December 23, 2009
NRC3-09-0051

References: 1) Fermi 3 Docket No. 52-033
2) Letter from Ilka Berrios (USNRC) to Jack M. Davis (Detroit Edison),
"Request for Additional Information Letter No. 16, Related to the SRP
Sections 2.5.1, 2.5.2, 2.5.3, 2.5.4, and 2.5.5 for the Fermi 3 Combined License
Application, dated November 13, 2009

Subject: Detroit Edison Company Response to NRC Request for Additional Information
Letter No. 16, Part I

Figure 2.5.1-246 Tectonic Structures in the Fermi 3 Site Vicinity

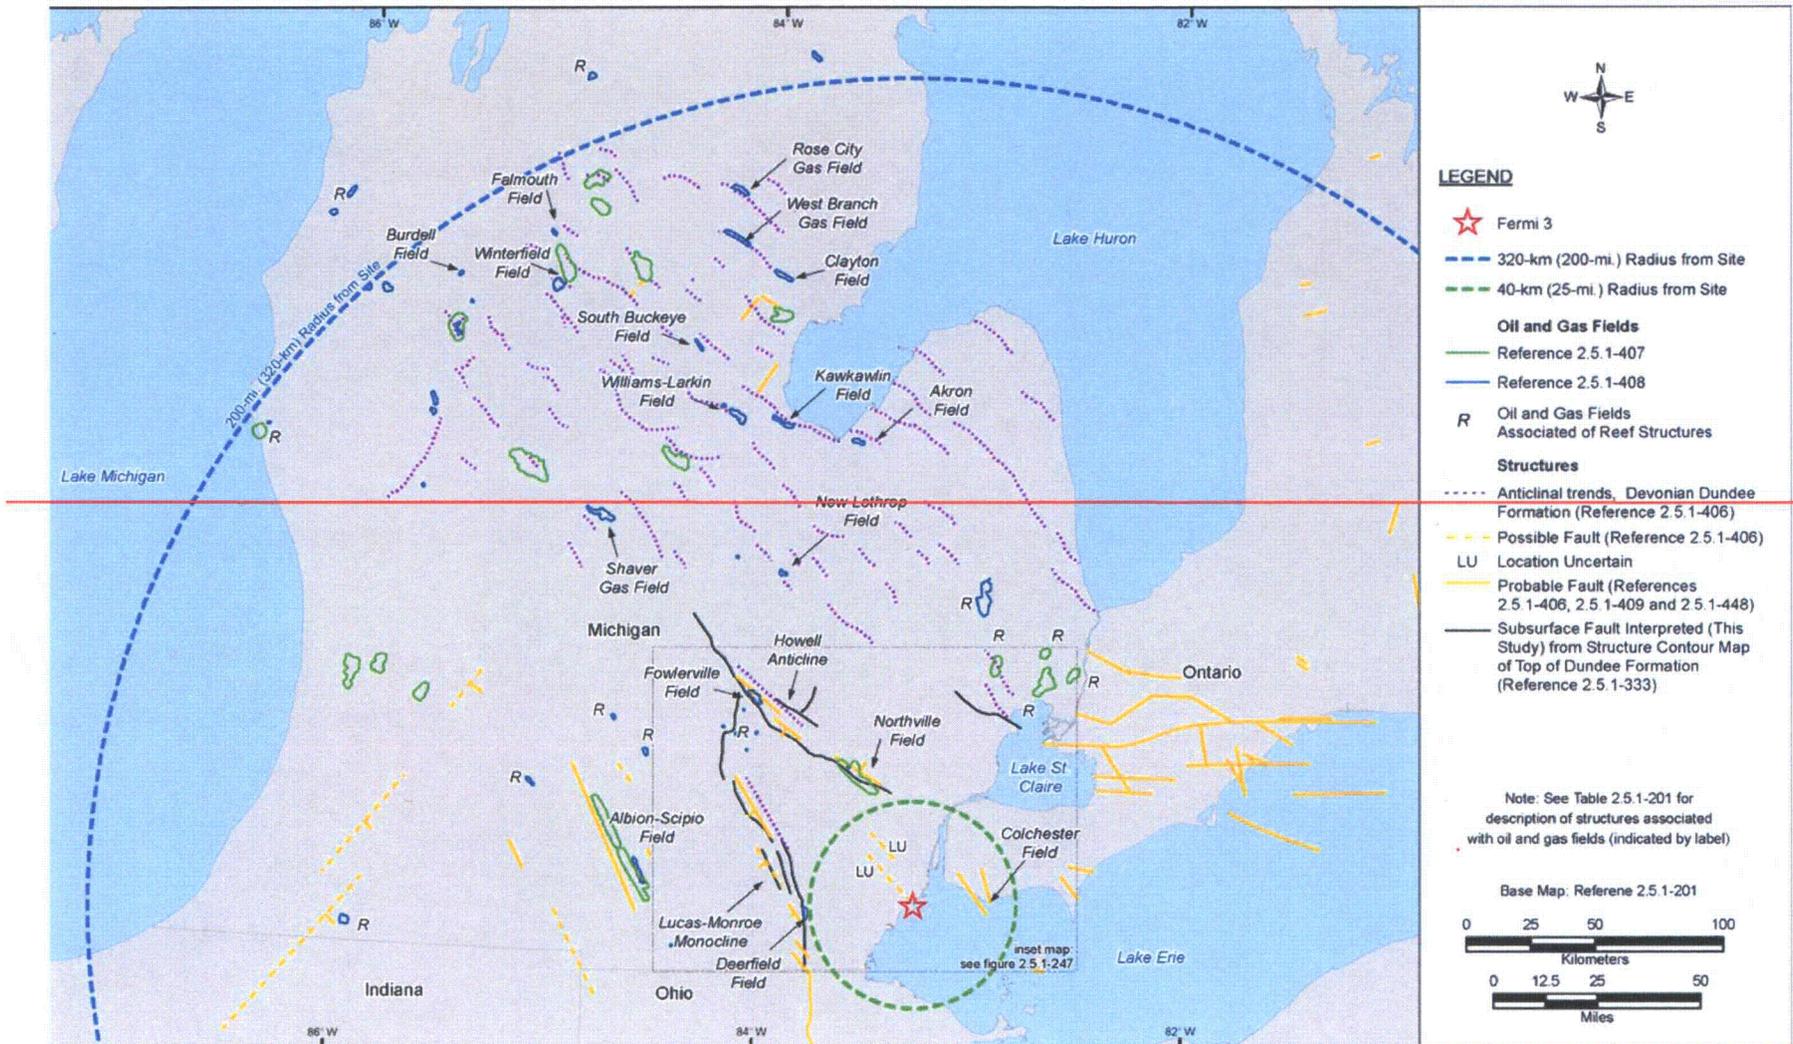
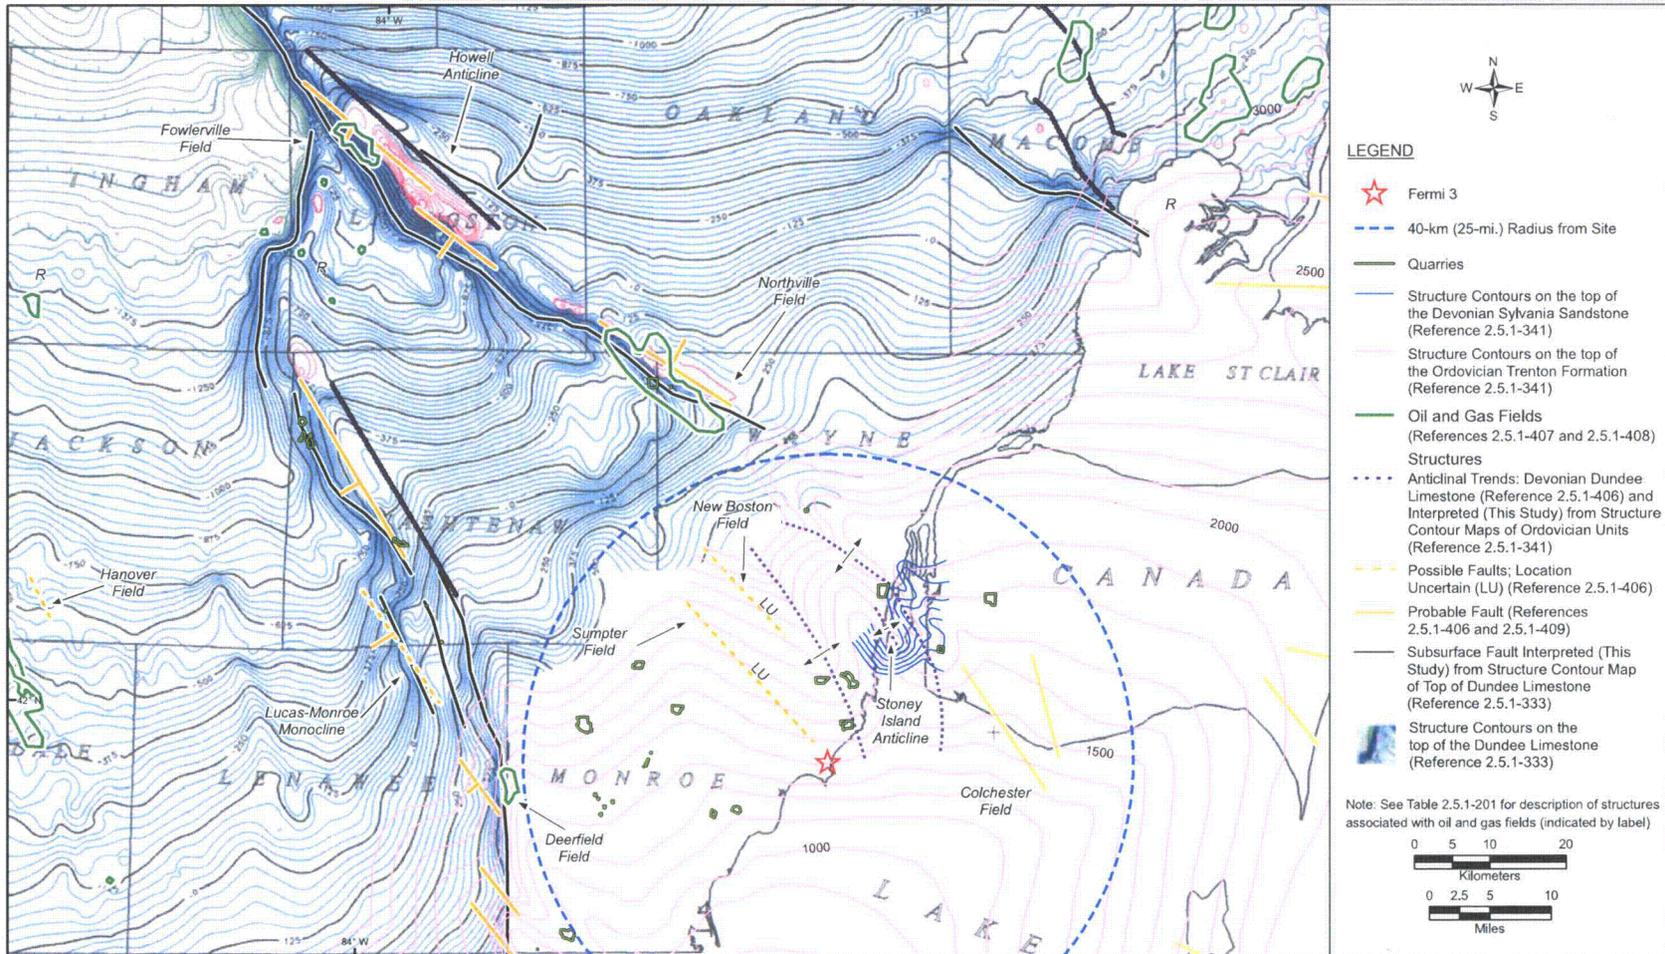
In FSAR Section 2.5.1.2.4.1, there are numerous incorrect figure references. For example, the discussion of Structures Within the Site Vicinity refers to FSAR Figure 2.5.1-234 ("Maps Showing Late Wisconsinan Ice Margins and Proglacial Lake Shorelines") when discussing the Bowling Green fault and the Howell anticline. When discussing the Bowling Green fault, the FSAR incorrectly refers to FSAR Figure 2.5.1-231 and to FSAR Figure 2.5.1-246. Please make the appropriate corrections.

The Bowling Green and Maumee faults shown on Figure 2.5.1-230 will be added to Figure 2.5.1-246.

Proposed markups to revise FSAR Section 2.5.1.2.4.1 and Figures 2.5.1-246 and 2.5.1-247 are attached.

Figure 2.5.2-237 Effect of Alternative EPRI (2004) Ground Motion Cluster Median Models on the Hazard Computed for the Fermi 3 Site [EF3 COL 2.0-27-A]

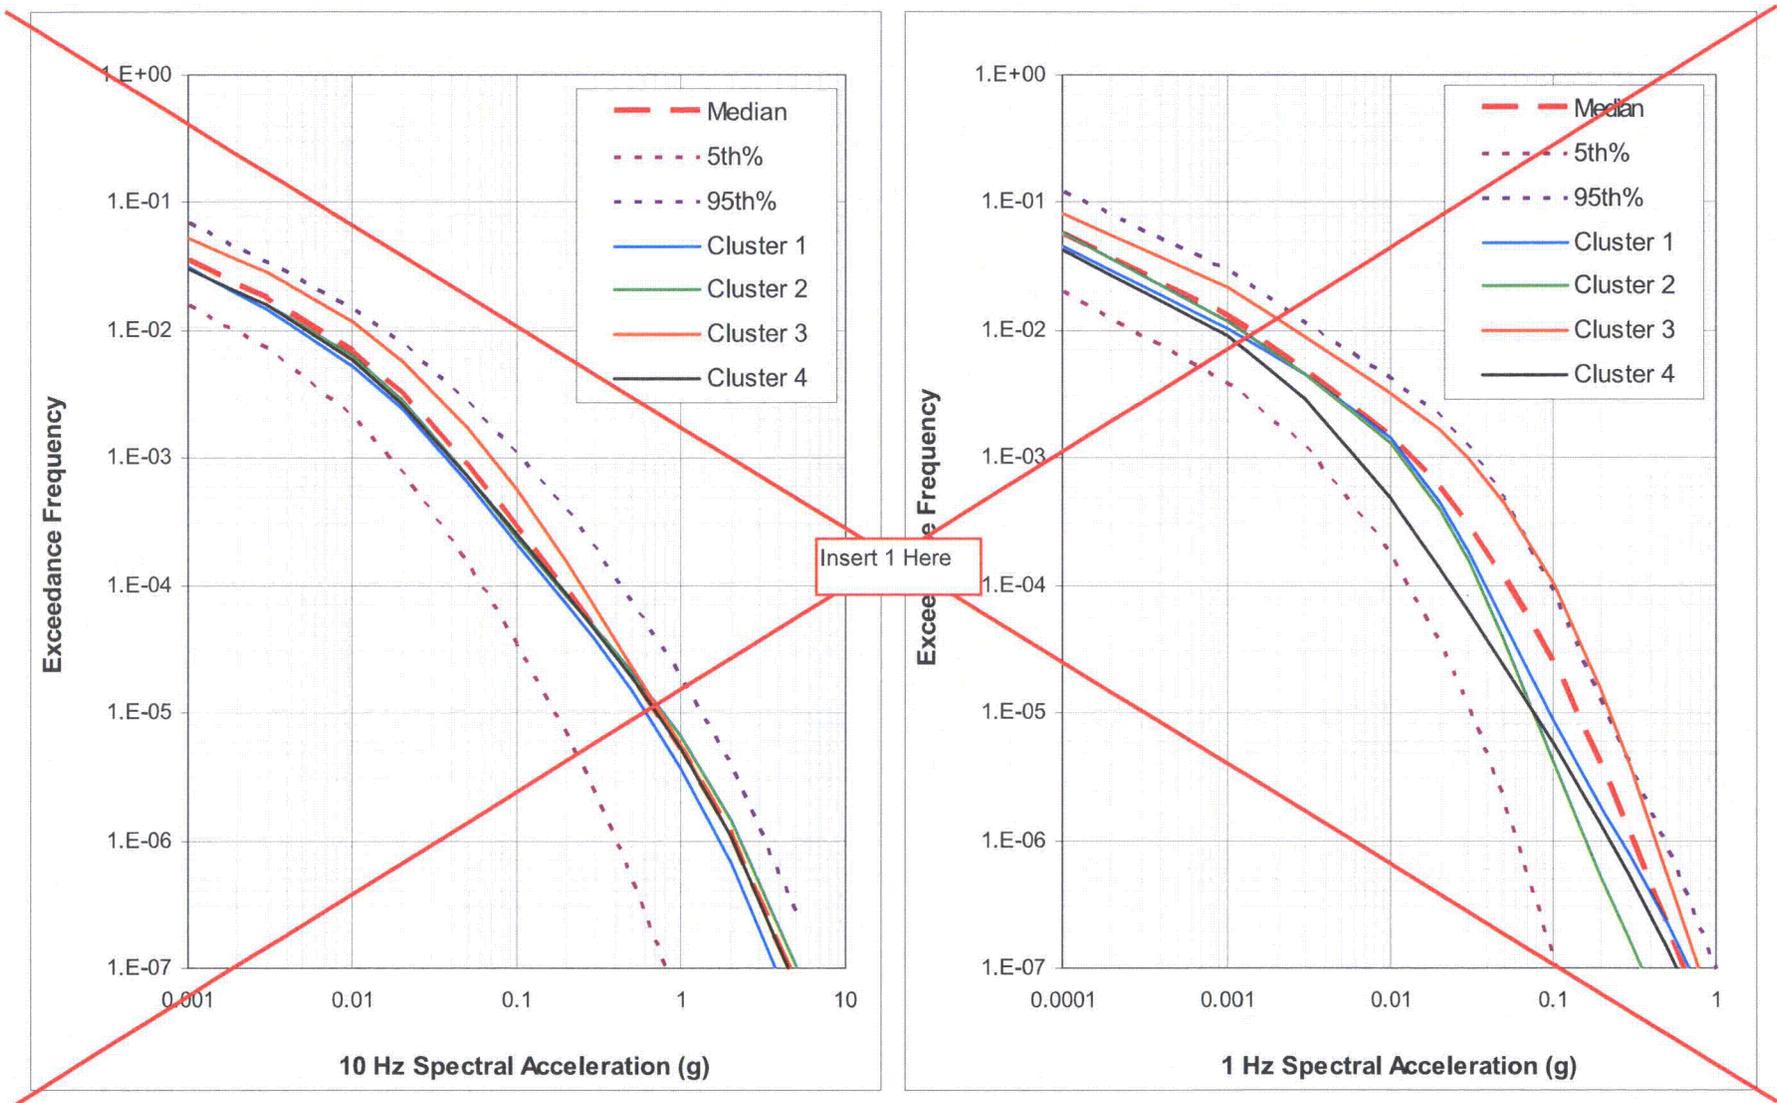
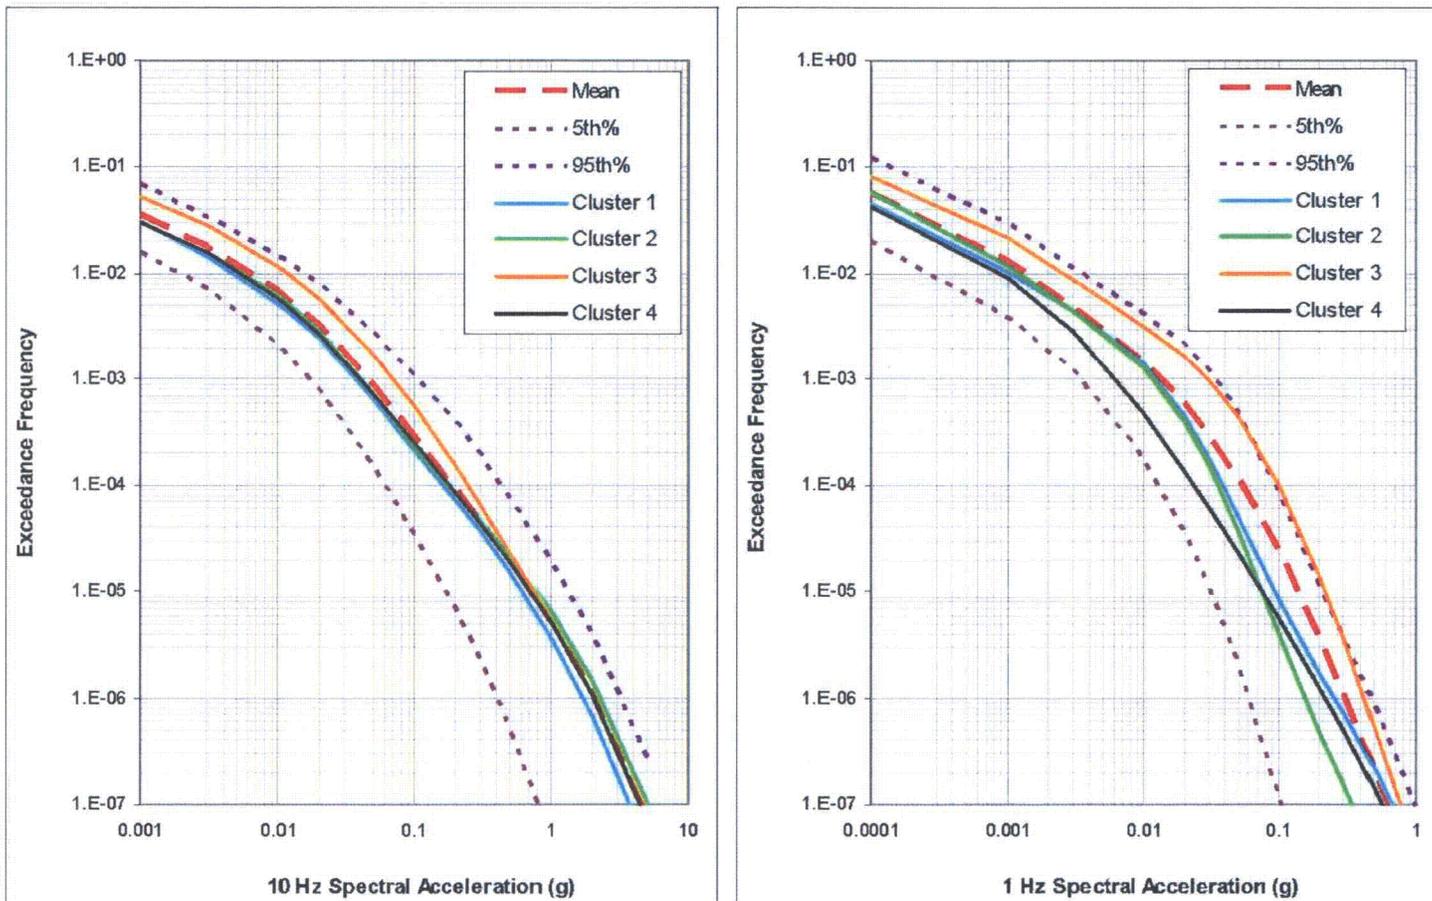
FSAR Figures 2.5.2-236 through 2.5.2-241 display the effects of various factors (seismic sources, ground motion models, model uncertainties, etc.) on the calculated seismic hazard at the Fermi site. However, these figures alternate between comparing mean and median ground motion. Please verify the content of the “mean” and “median” in those figures.

A proposed markup to the FSAR, Figures 2.5.2-237 and 2.5.2-238, is attached to revise “mean” instead of “median” in the legend.
